**Figure 2.1h**  
**Infrastructure Design Review**  
**- Turbine 08**

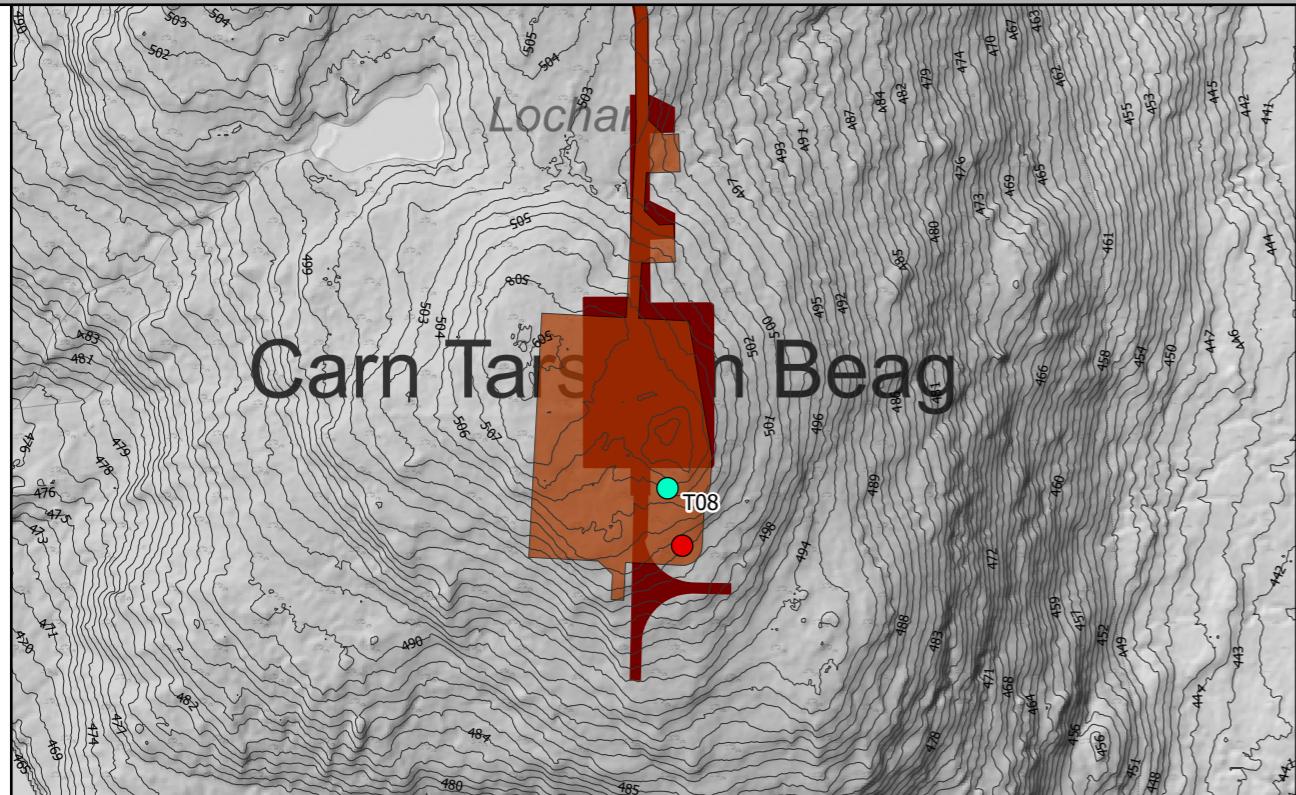
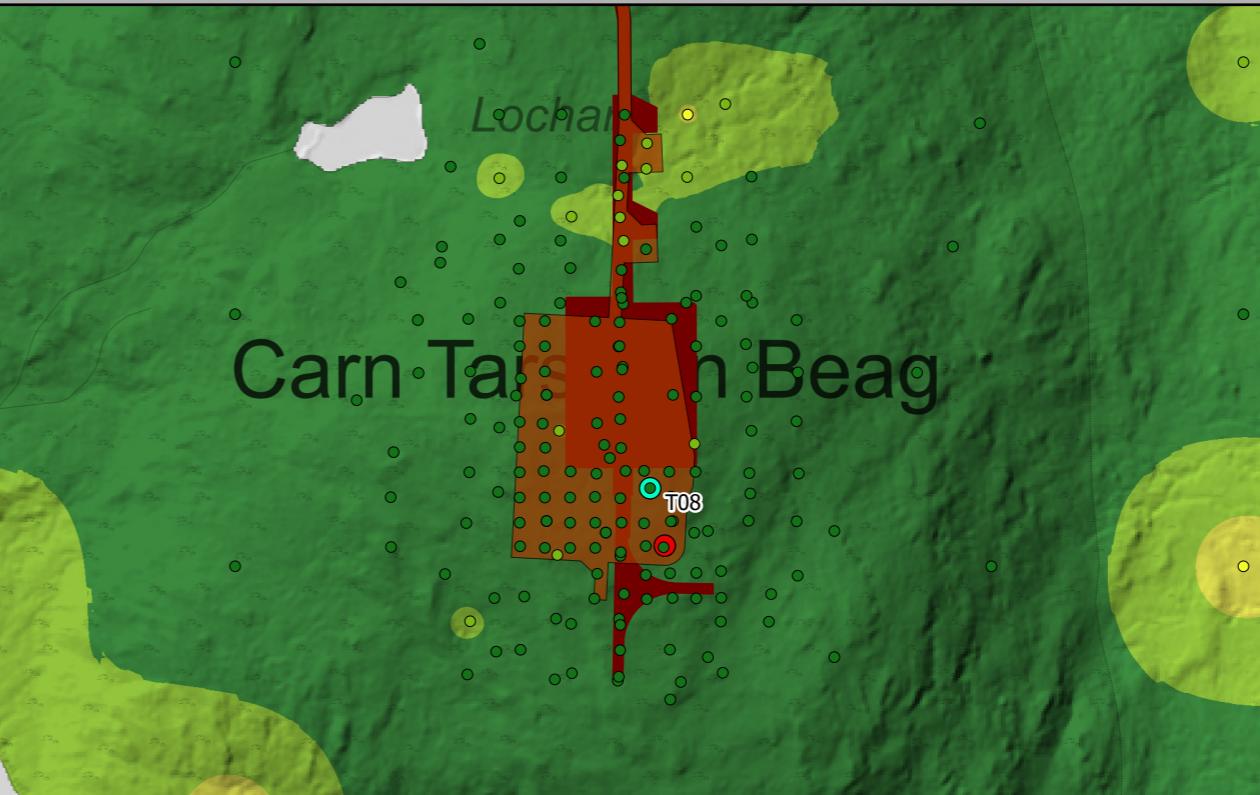
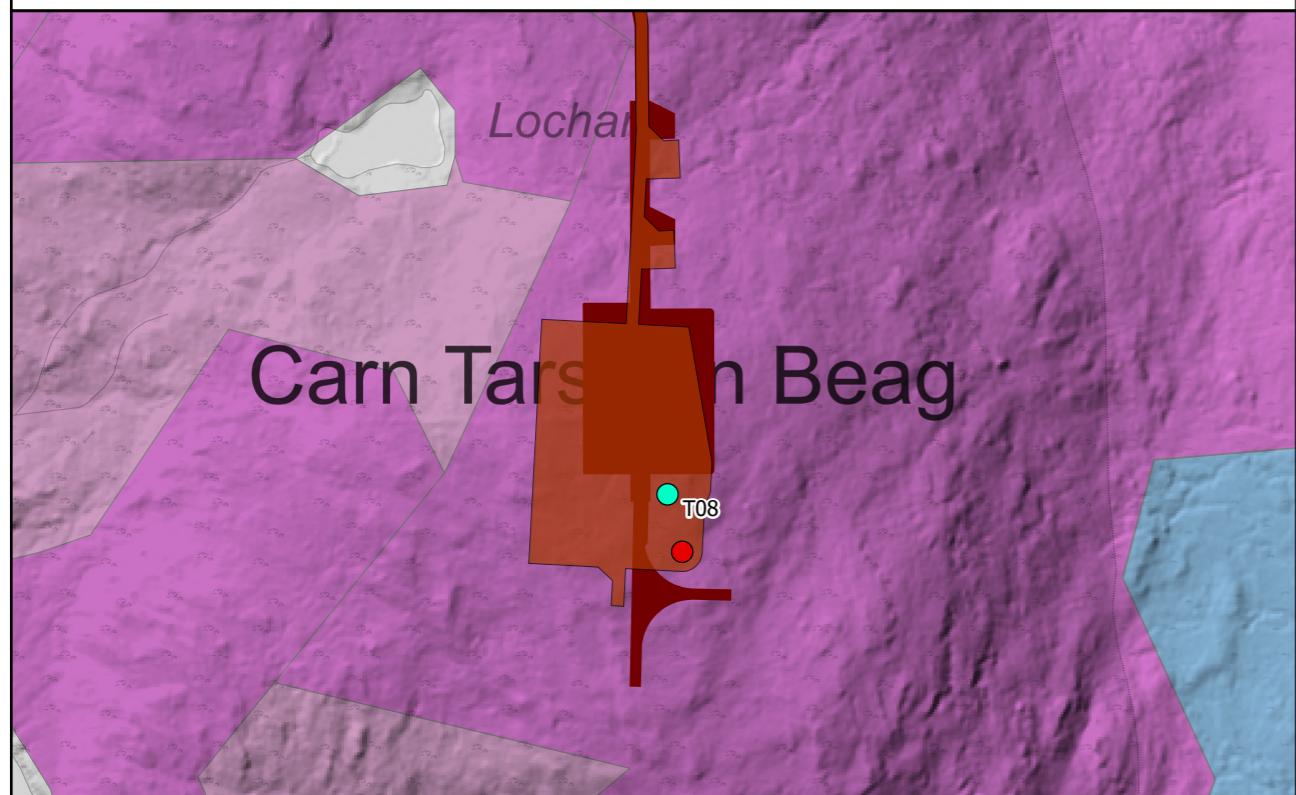
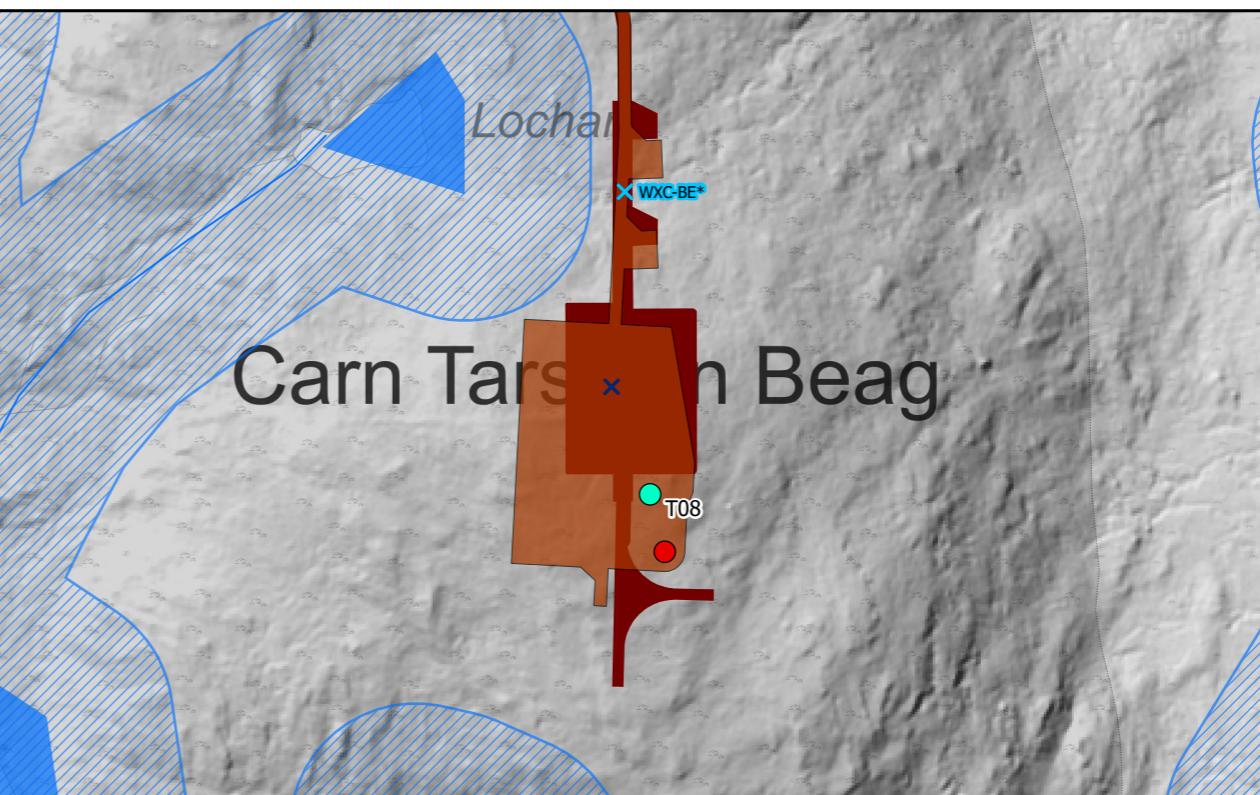
**T08: Reason for Moving:** This move helps maintain an acceptable level of turbine spacing to T07. Although the spacing is less than the desirable three rotor diameters, it is deemed acceptable as the neighbouring turbine is not within the predominant wind direction of this location. Additionally, it moves the rotor swept area outside the 2nd Fresnel zone of the communications link between the existing Bhlaraig Wind Farm site and Corrie Garth substation. This potentially eliminates the need to construct a new communication mast East of T16.

**Engineering:** With the movement of the Turning Head to the track between T07 & T08, this has allowed the Hardstand to be moved south. The position of the Hardstand has been located to avoid the steep slopes South of the turbine location.

**Geology Impacts:** The proposed infrastructure location is within the consented 50m micrositing buffer, including the hardstand, track, and turbine location. All infrastructure is situated in shallow peat. Moving the turning head to a location between T07 and T08 removes the need to build a turning head at the end of the track south of T08.

**Ecology Impacts:** As with the current consented infrastructure, the new layout is entirely within Wet Heath (M15c).

**Hydrology Impacts:** The proposed location is outside the 50m water buffers. Similar to the current consented location, a watercourse crossing is required on the track at the entrance to the hardstand.
